NDM
 NATHAN D. MAIER
 CONSULTING ENGINEERS, INC.
 Three Northpark / 8800 N. Central Expressway / Suite 300
 Dallas, Texas 75231 / (214) 738-4741

TRAFFIC SIGNS & MARKINGS PLAN
TOWN HOMES OF ADDISON

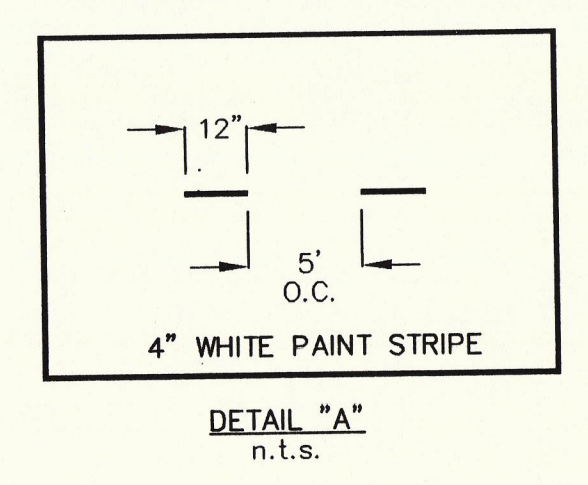
SEE DETAIL "A" "PUPPY" TRACKS THIS SHEET.

RECOMMEND ISLAND BE INCLUDED IN CONSTRUCTION PLANS. LANDSCAPING MUST MEET SIGHT DISTANCE REQUIREMENTS.
